Kentucky Transportation Cabinet Value Engineering Study Mountain Parkway Corridor – Construction Sequence 1

Final Value Engineering Study Report

Study Dates: May 12-16, 2014

November 14, 2014

VALUE ENGINEERING PROPOSAL CR-14

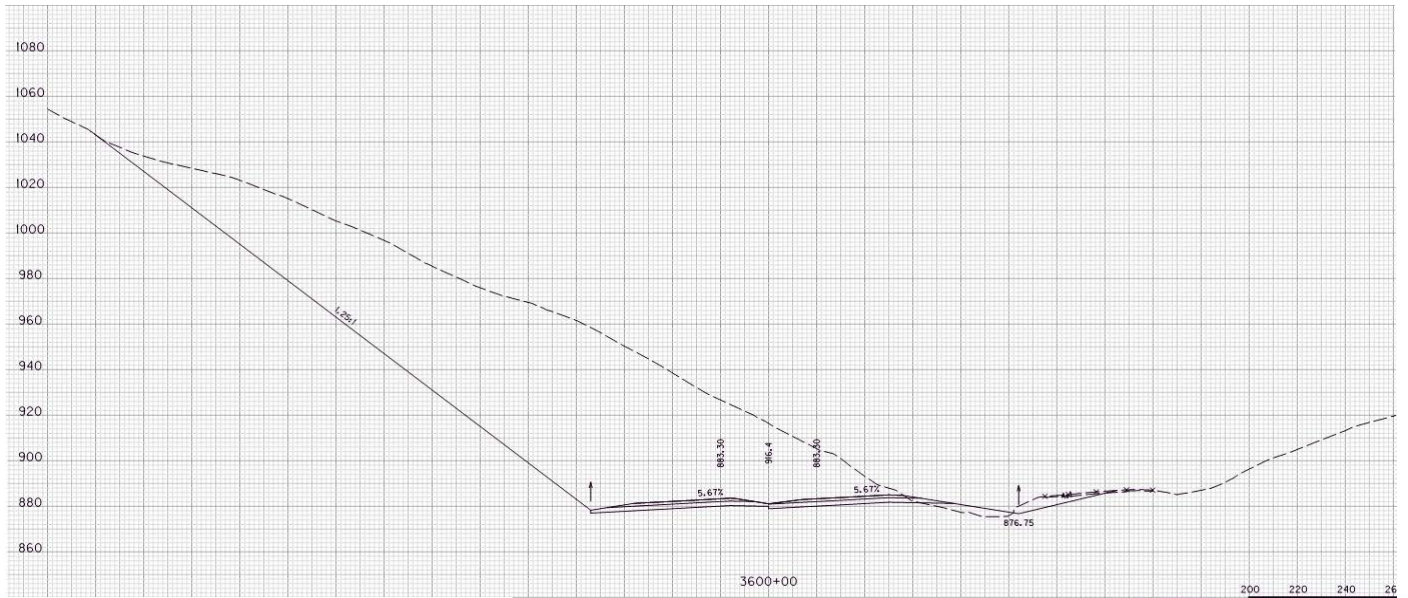
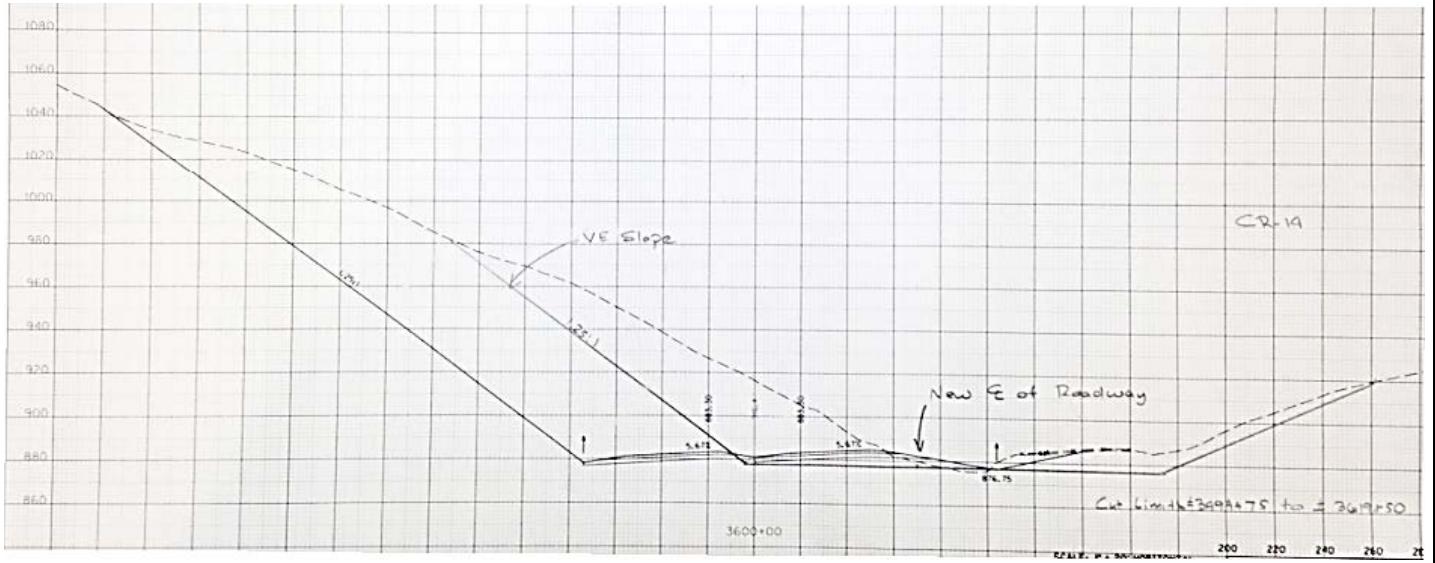
TITLE: Move alignment from Sta. 3595+00 to 3615+00, shift back to the existing alignment

VALUE ENGINEERING PROPOSAL CR-15

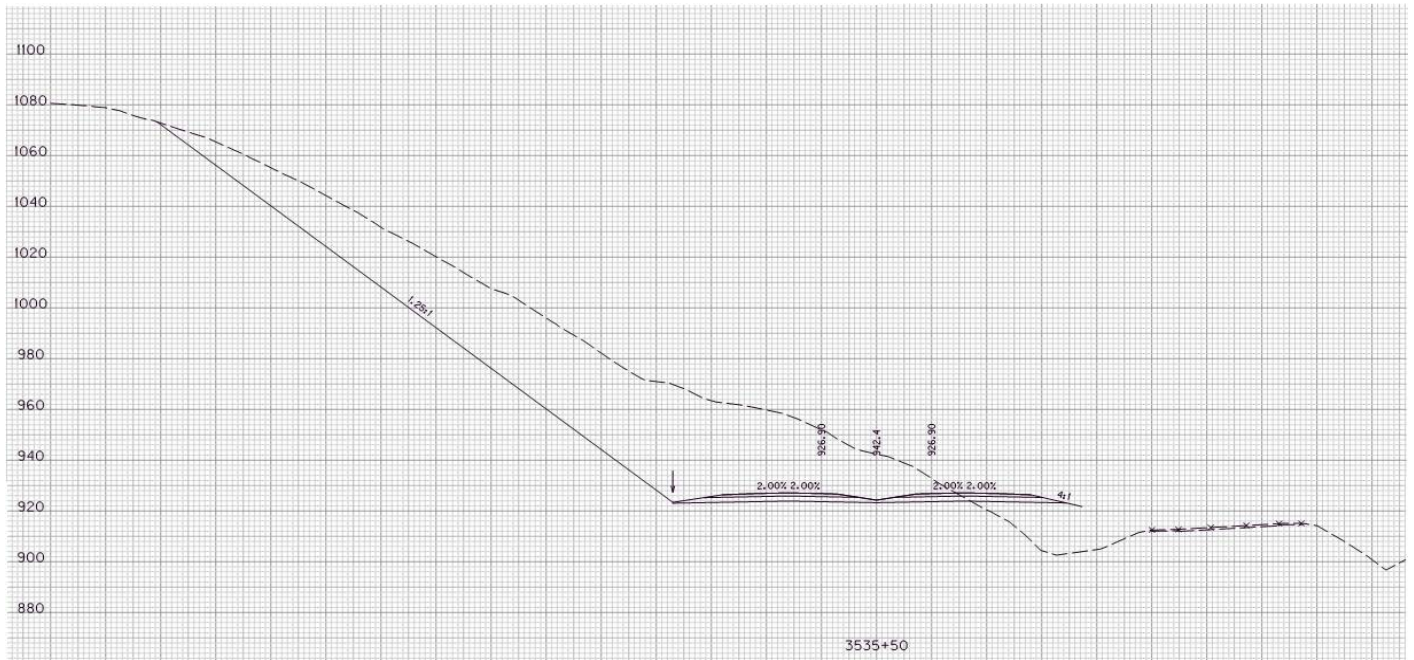
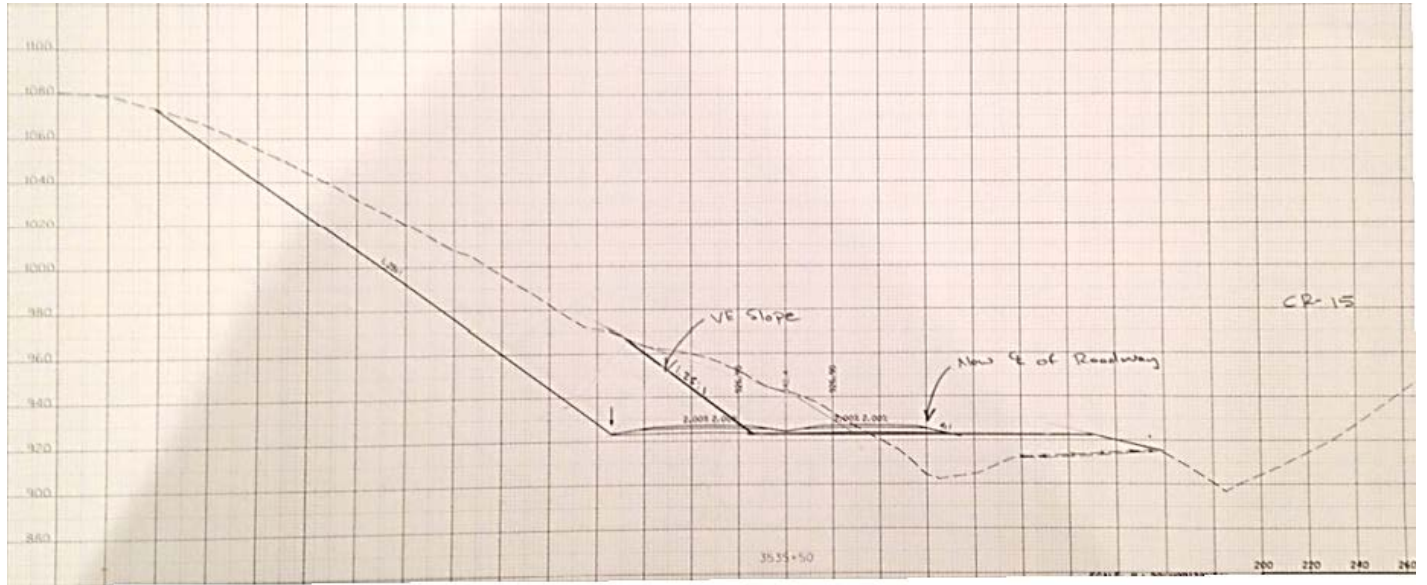
TITLE: Move alignment from Sta. 3530+00 to 3550+00

VALUE ENGINEERING PROPOSAL CR-01

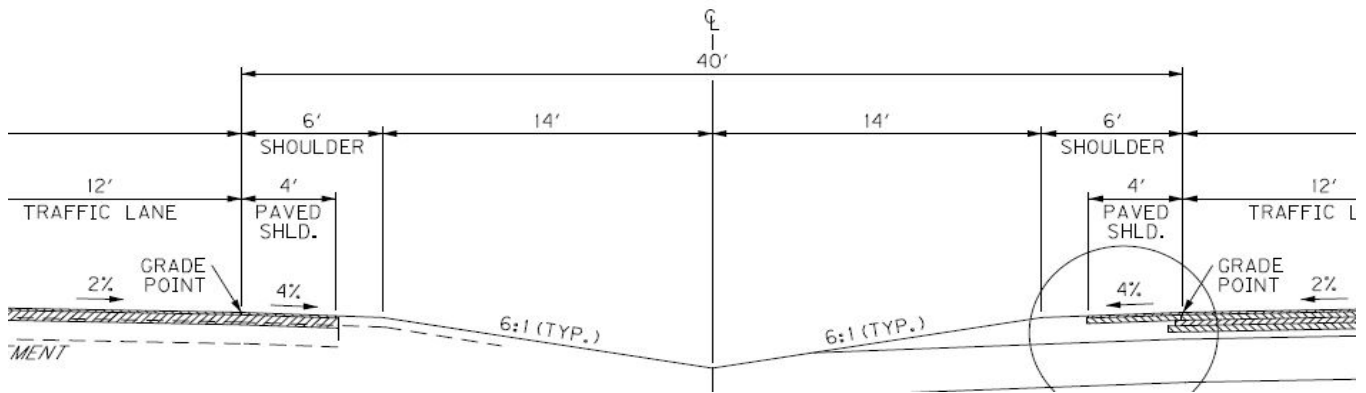
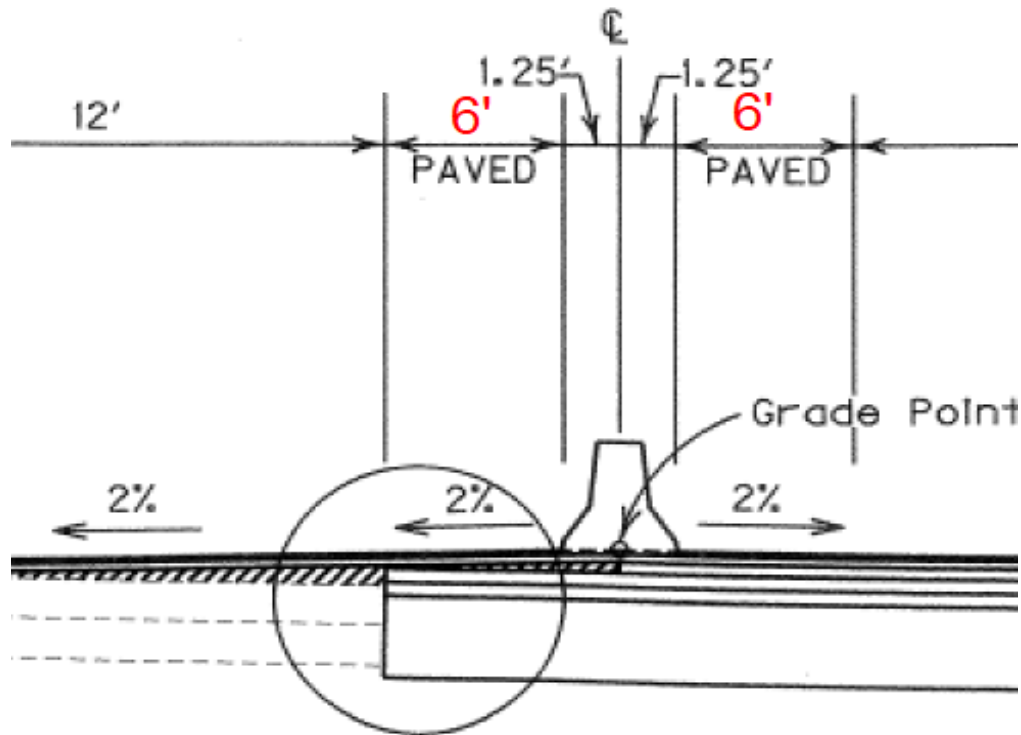
TITLE: Use median barrier to reduce foot print through cuts

Using (item No. 126-40) mainline excavation quantity of 6,830,500 CY (does not include left and right ditch cut excavation) and divided that quantity by the length of that project (4.2 miles) to find estimated 1,626,310 CY per mile. Multiplied the excavation per mile by the total miles (19 miles) for construction sequence 1 to get 30,899,890 CY estimate for this corridor. The proposed alternative excavation amount is 22.77% less based on a roadway width reduction of that percentage. Barrier median drainage boxes quantity assumes a box every 150 LF for 19 miles of roadway. Given the difficulty in determining pipe quantities, the over estimated quantity of boxes at an estimated cost of \$11,000 EA helps account for pipe and headwalls. Superelevated sections of roadway may not require boxes; therefore, there will be areas with box spacing greater than 150 LF.

VALUE ENGINEERING PROPOSAL CR-08

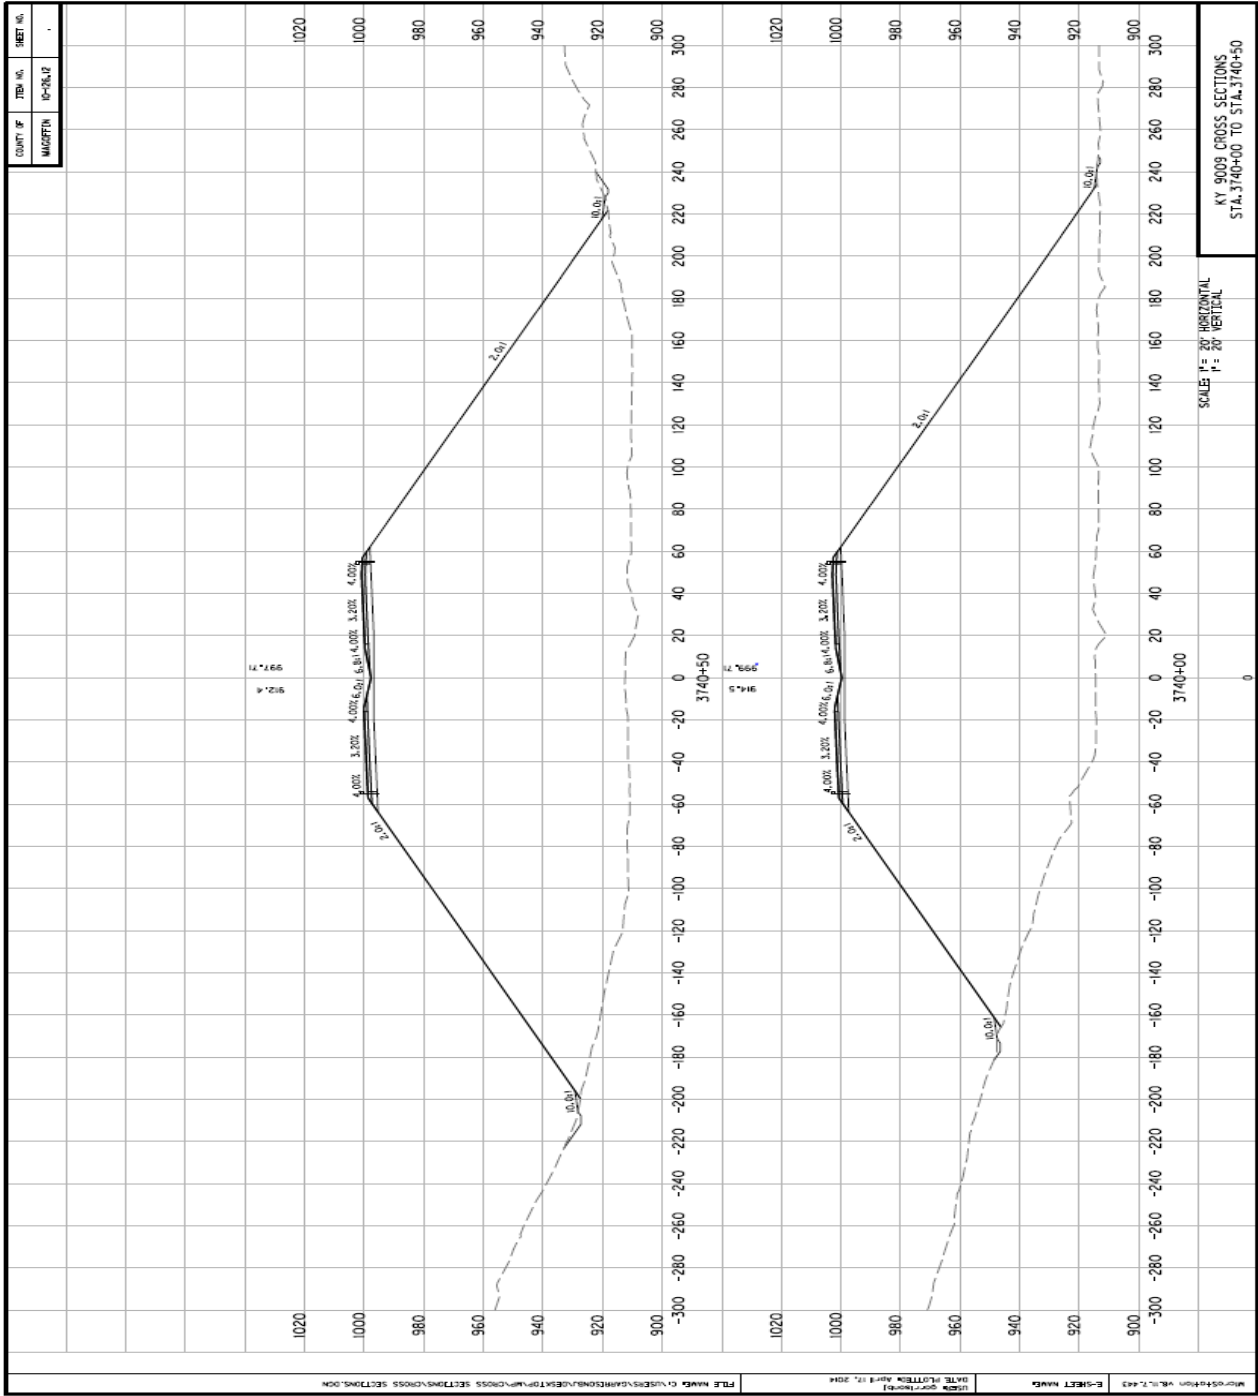
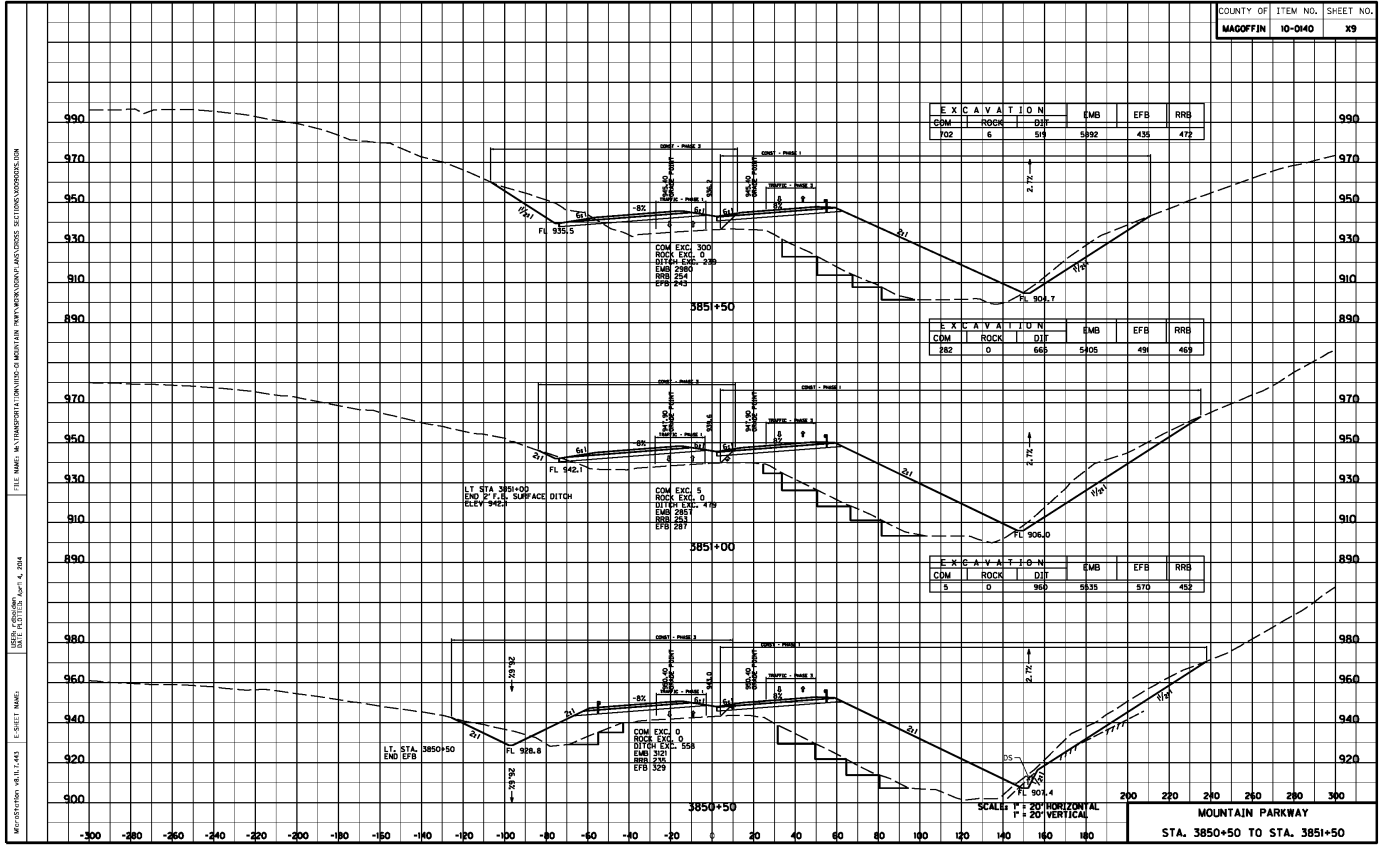
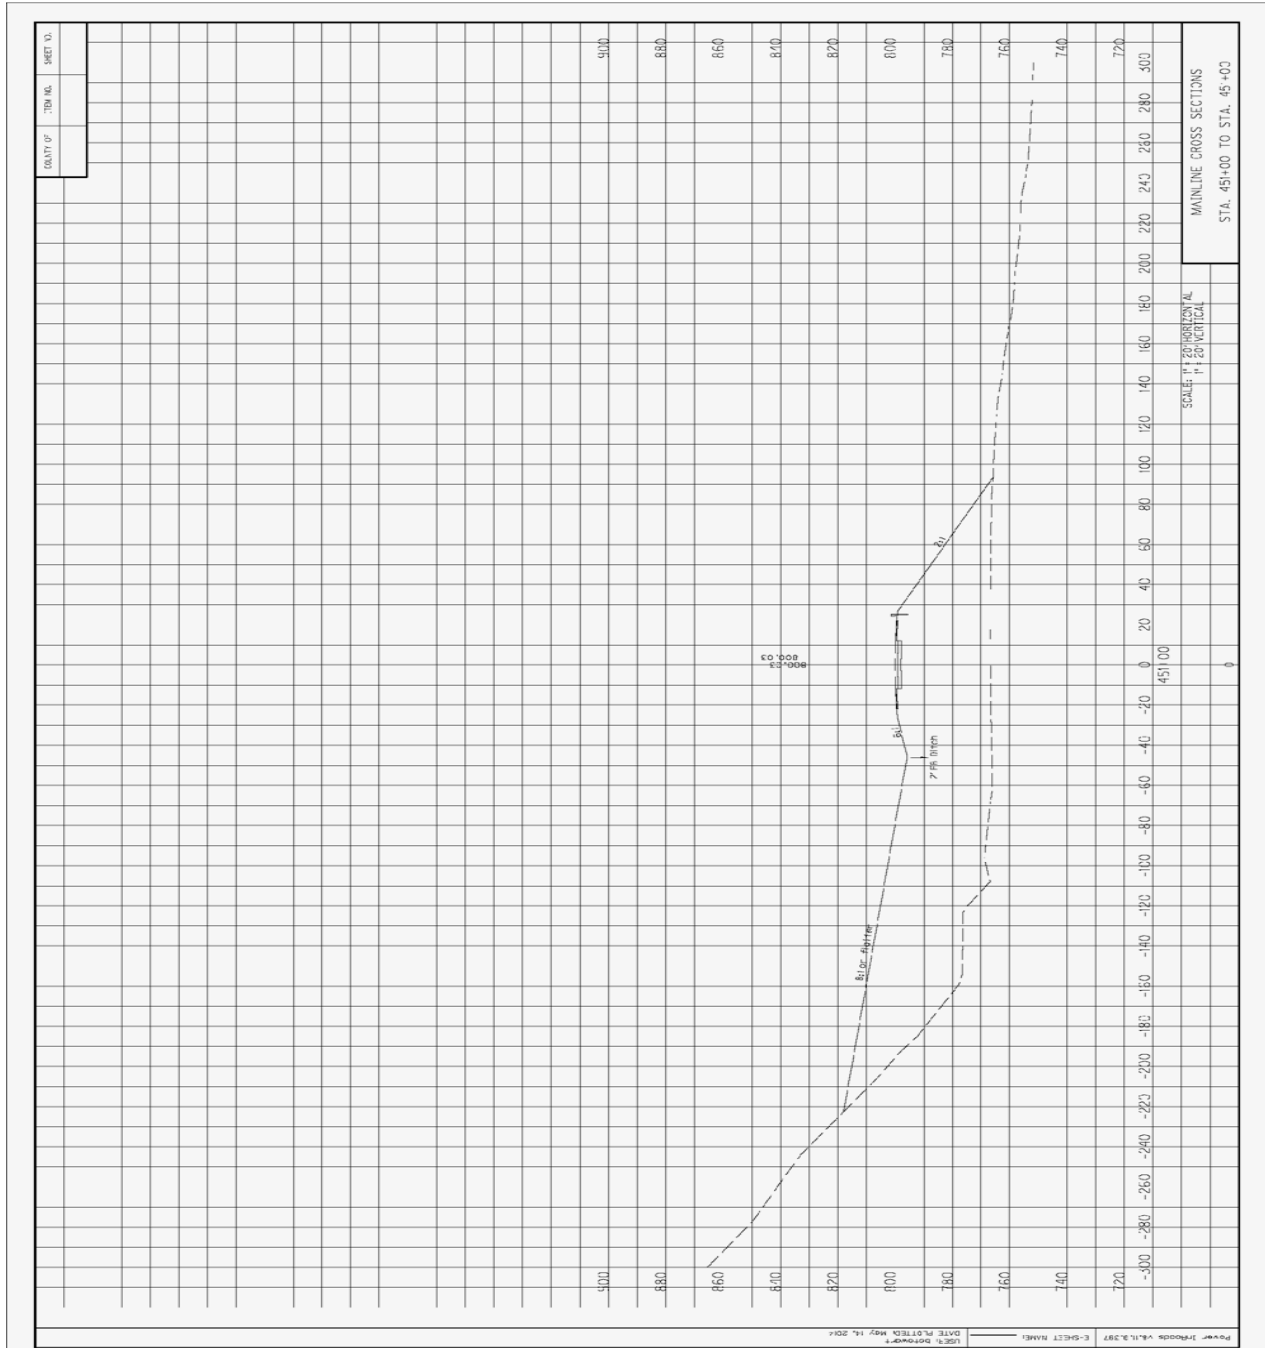
TITLE: Introduce false cuts to reduce fill area footprint and waste site needs			
FUNCTION: Clear Right-of-way			
BASELINE ASSUMPTION:			
The current typical sections show a minimum fill slope of 2:1 with guardrail and a 4:1 desirable.			
PROPOSED ALTERNATIVE:			
When ever feasible, (the embankment area in between two steep cuts) false cut areas could be introduced to waste excess material within the project.			
BENEFITS		RISKS/CHALLENGES	
• Reduces the size of waste areas		• Monitor additional fill areas	
• Reduces the haul length of waste material		•	
• Better pricing for earthwork		•	
• Reduces the amount of guradrail		•	
• Reduces cost of guardrail replacement		•	
•		•	
•		•	
•		•	
COST SUMMARY		Initial Costs	O&M Costs
BASELINE ASSUMPTION:		\$ 85,192,826	\$ -
PROPOSED ALTERNATIVE:		\$ 80,541,908	\$ -
TOTAL (Baseline less Proposed)		\$ 4,650,917	\$ -

TITLE: Introduce false cuts to reduce fill area footprint and waste site needs

Above sketch is provided for Section 10-140.00 only; however, it is representative of what can be anticipated for the entire Mountain Parkway corridor. Proposed sketch (next page) illustrates what may be applied to the entire corridor, and cost detail reflects anticipated cost savings for the entire Mountain Parkway corridor.

VALUE ENGINEERING PROPOSAL DS-01

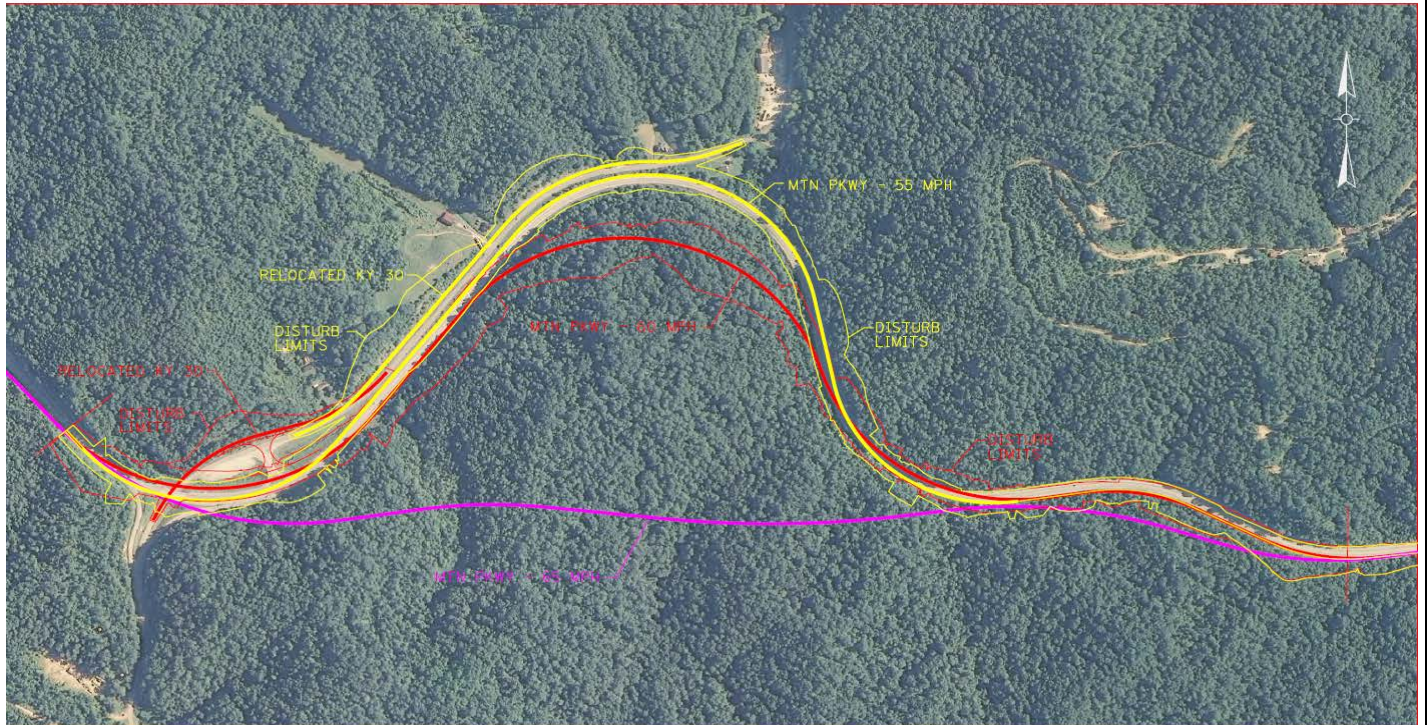
TITLE: Change design speed from 65 mph to 60 mph to reduce earthwork

PROJECT	CONSULTANT	ITEM NO.	STATION		LENGTH MILE	EXCAVATION (MILLION CY)				
						PROJECT		SECTION		
						65 MPH		60 MPH		
		BEGIN	END		CURRENT	CURRENT	REVISED	SAVINGS (millions)		
1A	LOCHNER	10-126.70				0.85			N/A	
1B	HMB	10-126.60				2.50			N/A	
1C	EA	10-126.50				2.41				
			3248+00	3287+00	0.7		1.78	0.42	1.36	
1D	AEI	10-126.40				8.23				
			3456+00	3517+00	1.2		4.73	1.51	3.22	
			3527+00	3551+00	0.5		0.28	0.09	0.19	
			3590+00	3603+00	0.2		0.39	0.15	0.24	
1E	MEC	10-167.00				1.53				
			3603+00	3634+00	0.6		1.00	0.32	0.68	
1F	PB	10-126.12				3.70				
			3705+00	3784+00	1.5		1.92	1.48	0.44	
1G	VM	10-140.00				1.34				
			3848+00	3891+00	0.8		0.43	0.20	0.23	
						5.5	20.56	10.53	4.17	6.36
TOTAL DIFFERENCE									6.36	
TOTAL CONSTRUCTION SEQUENCE 1						20.56			14.20
